Author's response to Editor initial decision and comments from Reviewers

Notes on the estimation of resistance to flow during flood wave propagation

M.M. Mrokowska, P.M. Rowiński, M.B. Kalinowska

Figure 3. Temporal variability of flow depth h and mean velocity U for experimental flood waves in the Olszanka River.

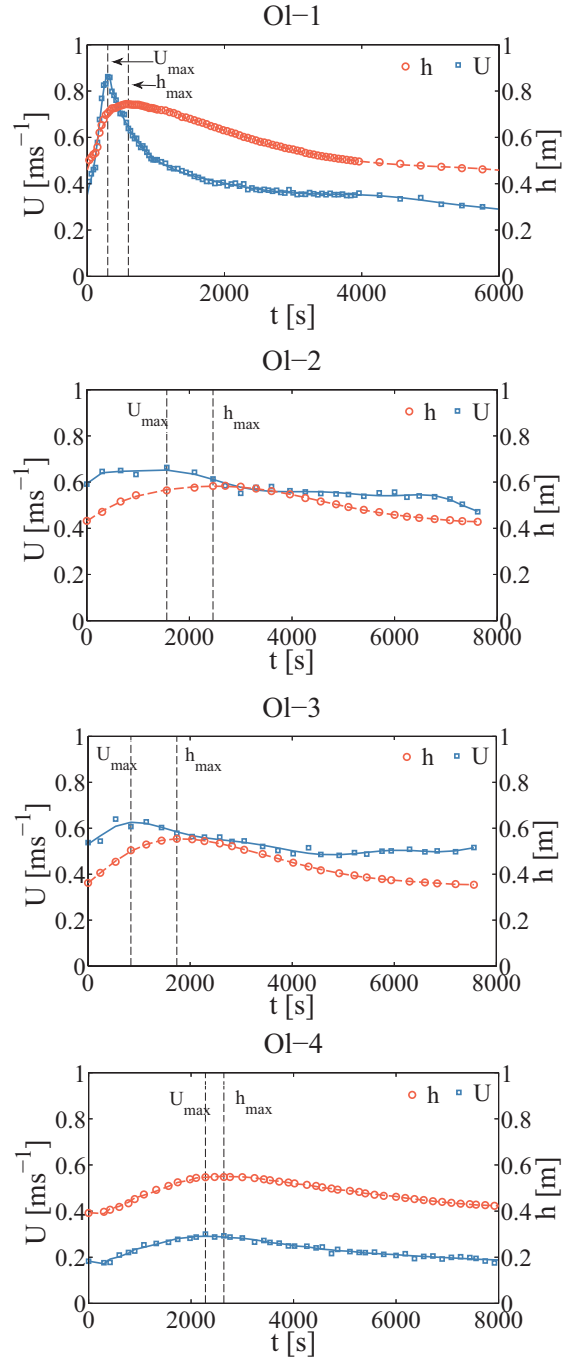
RC#14: Fig 2: used dh/dx in figure and θ in caption. Please, be consistent Fig 4: used symbols to indicate h_{max} and U_{max} . In other figures you used vertical lines.

AR#14: We have corrected caption in Fig 2, and added vertical lines in Fig 4 to be consistent. Please note that in the revised paper the order of figures has changed. Fig 2 is now Fig 5 , and Fig 4 is now Fig 3.

Figure 7. Comparison of terms of the momentum balance equation for ~~experimetal~~ experimental flood waves in the Olszanka River.

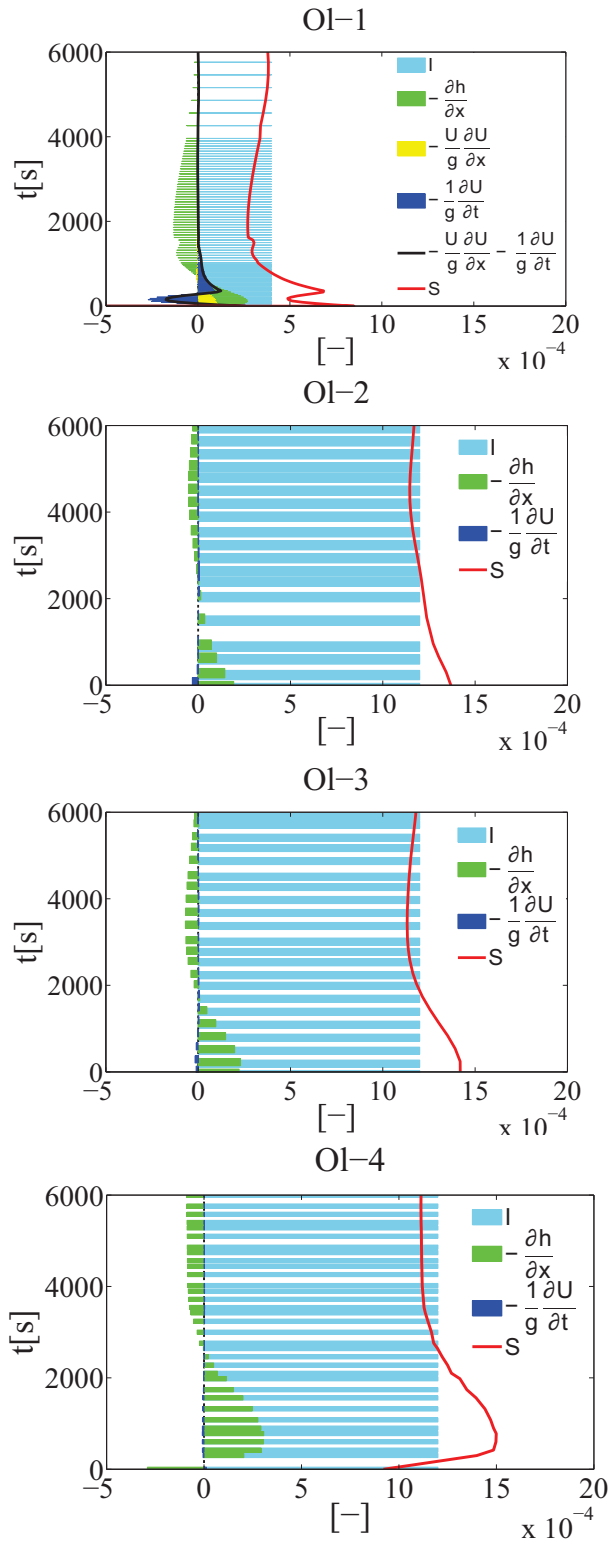
RC#9: iv) Results and Conclusions. In Fig.7 the magnitude of different terms in balance equations (3,4) is shown. Unfortunately, it's not given to know how these terms have been computed. I don't think that they are inferred from the recorded data. I guess that they are assessed by using Eq.(3) and (4). If so, what is the hydraulic model applied and which boundary conditions are applied?

RC#11: Based on that, I'm not so convinced that in CS1 the wave has a dynamic behavior; as the same authors have specified and looking at Fig.7, the inertial and convective forces (acceleration terms) have opposite sign (as expected) and are not so significant (p.13328). As a result, the pressure force should be prevalent also in CS1. To remove any doubt, the better thing would have been to compute the difference between convective ($f(du/dx)$) and local inertial force ($f(du/dt)$) at that section and maybe plotting it in Fig.7 as well.

AR#9: Terms are calculated from recorded data. No hydraulic model has been applied.

All terms are evaluated analytically from measurement data.

AR#11: Your doubts are right. In fact, it has not been stated that the wave in CS1 is dynamic for sure. In P13329 lines 5-10 of the original manuscript it is said that for the wave in CS1 more terms of momentum balance equation are significant than for waves in CS2, and for this reason application of dynamic formula should be considered and verified. We treat presented case as a working example of application of friction velocity formula, and want to go through all problematic aspects of this case with the reader to show him/her all possible problems. Please note, that after deeper analysis we have concluded that the wave may be described as diffusive (P13330 lines 12-14 of the original manuscript).

In the case of data set Ol-1, along the rising limb local acceleration term is slightly bigger than the advective one, which may indicate dynamic character of a wave.
